他廠 6HP 變速箱翻修不良圖示說明

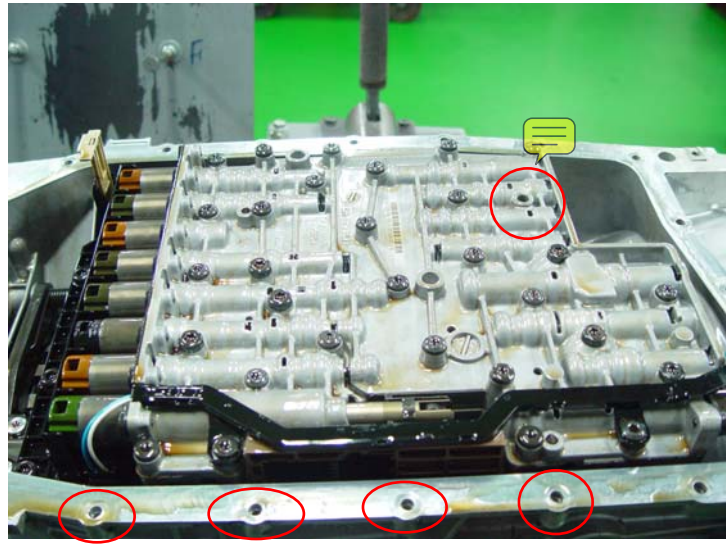
說明	他廠(X 辰、雍 X)																																								
<p>X 辰不良品送修之 6HP26 變速箱                      號碼為 1068 010 052                      序號為 0151954</p>																																									
<p>上面有 X 辰標記                      在 98 年 06 月 21 日曾經修理過，不到半年又掛點損壞。</p>																																									
<p>此變速箱 X 辰裝錯閥體，拆下閥體為 346 之號碼</p>																																									
<p>346 之電腦閥體乃為 1068010057 或 1068010059 之變速箱所裝，非本變速箱 1068010052 所裝(052 應裝 332 之電腦閥體)</p>

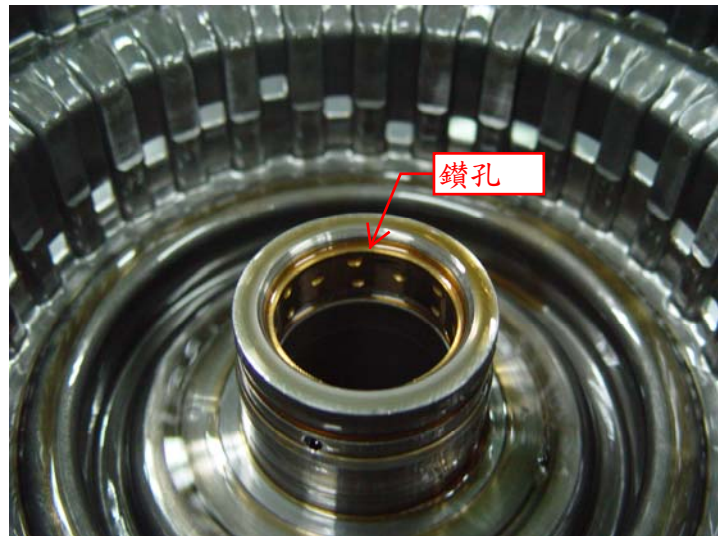
由於未按扭力磅數鎖油底殼，導致外殼鎖螺絲處凹陷不平，如此易導致油底殼變形漏油(油底殼材質為朔料材質)。  
閥體螺絲少鎖一個

軸頸銅套鑽孔，誇張。

B 組缸體軸頸銅套上鑽孔，非正規做法，且無技術依據，為土法煉鋼，變速箱品質毫無保障，有損客戶權益。

由於組裝品質不良，加上電腦閥體裝錯，導致內部燒毀嚴重。
